LINCOLN CITY/LANCASTER COUNTY PLANNING STAFF REPORT

P.A.S.: Special Permit #1913 - Heritage Lakes CUP **DATE:** February 20, 2002

Preliminary Plat #01004

Special Permit #1913 Preliminary Plat #01004 Heritage Lakes Community Unit Plan

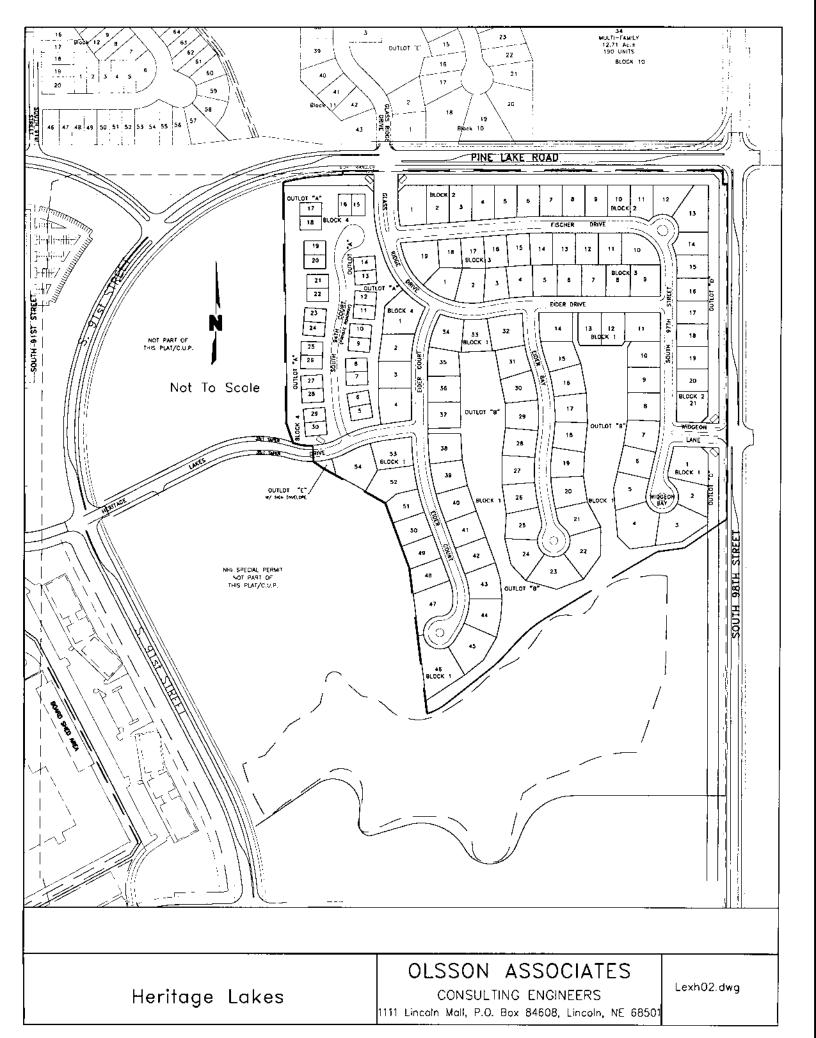
In reviewing the dedicated transmission line or other electrical easements shown on this plat, LES does not warrant, nor accept responsibility for the accuracy of any such dedicated easements.

ALLTEL, Time Warner Cable, and the Lincoln Electric System will require the additional easements marked in red on the map, along with blanket utility easements over all of the outlots.

It should be noted, any relocation of existing facilities will be at the owner/developer's expense.

Any construction or grade changes in LES transmission line easement corridors are subject to LES approval and must be in accordance with LES design and safety standards.

Landscaping material selections within easement corridors shall follow established guidelines to maintain minimum clearance from utility facilities.
